DESIGN ADVISORY COMMITTEE

8 OCTOBER 2015

DA117/15 201 (LOTS 2885) MOUNTS BAY ROAD, CRAWLEY – PROPOSED FIVE LEVEL RESIDENTIAL DEVELOPMENT CONTAINING 33 MULTIPLE DWELLINGS AND 39 CAR PARKING BAYS

DA118/15 206 (LOT 50) ADELAIDE TERRACE, EAST PERTH – 11-

2015/5357; 201 MOUNTS BAY ROAD, CRAWLEY (PERSPECTIVES)

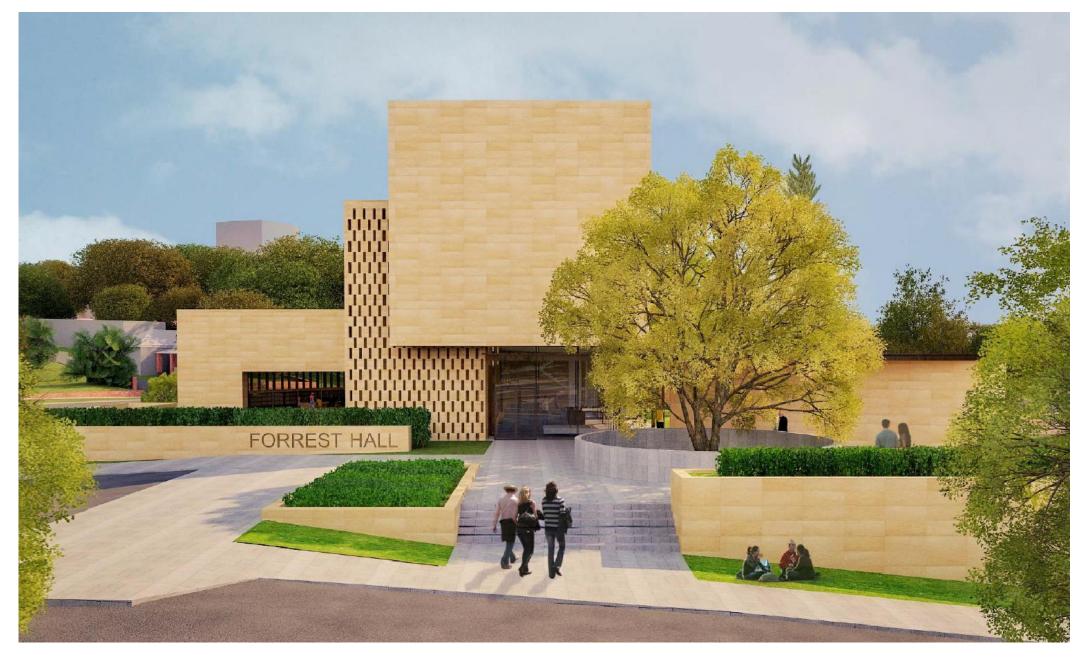
- 1. is of the opinion that the proposal is a well resolved and interesting building that has an appropriate bulk and scale for its location and that the design is sympathetic to the language of the University of Western Australia campus development;

- 2. considers that the courtyard wall height to Mounts Bay Road should be reviewed, with particular attention to the adjacent landscaping, ensuring it reduces the perceived impact of the wall; contributes to the pedestrian environment and incorporates canopy trees;

- 3. requests that further consideration be given to the sense of arrival when approaching the development through the car park, with attention being given to the materials and to equitable access to the pedestrian entry; and

- 4. notes that the roof forms the fifth elevation of the building that can be viewed from high rise developments nearby and that further detail be provided to ensure that the roof design and finishes should make a positive contribution to wider vistas.
